SUNDRY NOTICES AND REPORTS ON WELLS
Do not use this form for proposals to drill or to re-enter an abandoned well. Use form 3160-3 (APD) for such proposals.

Burnett requests a variance to the approved APD requiring cement be circulated to surface behind the 7? production casing. Our plan of action is to complete the well as discussed below:

**GISSLER A #41
 LOCO HILLS GLORIETTA YESO
 UNIT O, SEC. 14, T17S, R30E
 330' FSL, 1550' FEL
 EDDY CO., NEW MEXICO
 30-015-39931**

CONDITIONS OF APPROVAL

WBD AS OF 5/2012- NOT TO SCALE

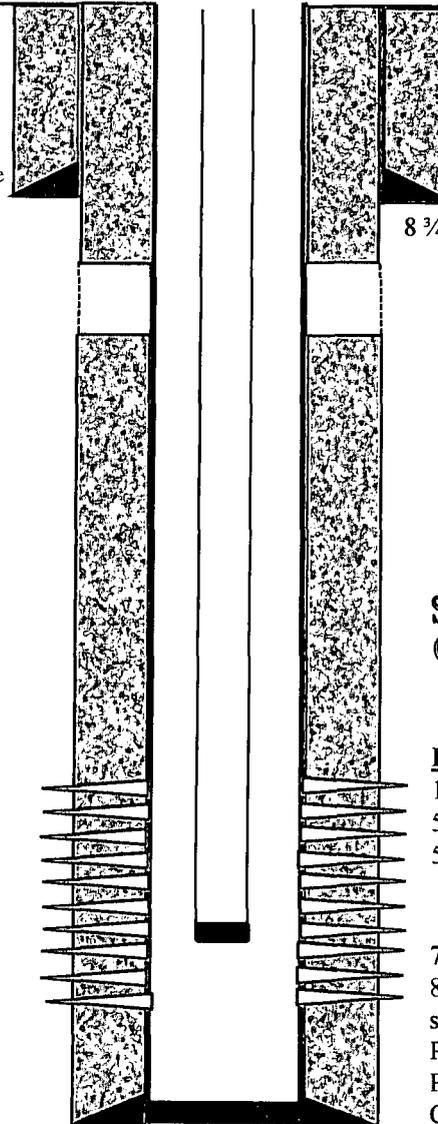
5) & 6) Run production log including temperature log and noise log from 2700' to surface to determine if flow is occurring behind the production casing. Considering results of this survey, previous CBL, and the configuration of well bore, that is, DV at 2612', TOC by CBL at 970', ECP at 393', 10.75" CSA 267', the procedure below is anticipated. This procedure is to cover salt area behind production casing with cement.
? Perf casing approximately 960' & 385'.
? Perform 'suicide squeeze' through holes at 960' circulating out holes at 385'. Circulation will be established to clean up 'backside' and determine cement volumes to pump.

NOTE: Since CBL indicates sufficient bond below DV, we request remaining perforations and fracture treatments be completed prior to remedial cementing.

The ECP definitely is set, at the depth of 393'. The proposed perforations are 960' and 406'. My reasoning for starting the noise and temperature log at 2700' is to be below the DV tool, which is all below the lost circulation zone. The lost circulation zone was 353', below the surface casing setting at 267'. This would begin all surveys below all the problem zones.

The CBL indicates cement behind casing below the DV with bonding ~~good to fair~~, *Fair To scattered* but not free pipe. The proposal of treating pressure at 80% of burst rating of pipe is very standard with new pipe. The consultant, John Ely and Associates, who helps design Burnett fracs, pumps fracs every day using this guideline, many of them are down casing without cement support. I will add that when there is no cement the guideline is same considering hydrostatic and depth. The casing is always tested to 90% of burst prior to frac. It would be tested prior to each of the 2 successive fracs with bridge plug between intervals. These are standard procedures in Burnett's completion procedures.

1. **Surface disturbance beyond the originally approved pad must have prior approval.**
2. **Hydrogen Sulfide has been reported as a hazard. Functional H2S monitoring equipment shall be on location.**
3. Approval given to add additional pay zones via perforations and frac procedure prior to doing remedial cement work to cover the exposed salt zone behind the production casing

5. **Step 5 & 6 of operator's procedure, the production log including temperature log and noise log will be run from 4500 feet to surface.**
6. **The tracer survey log and production log shall be run after 70% of load water from frac has been recovered. Also, a casing integrity test shall be performed on the production casing at 90% of burst.**

7. **All results from step 6 above shall be reported to the BLM as soon as possible to determine if remedial cement work will be required to cover the exposed salt zone behind the production casing.**
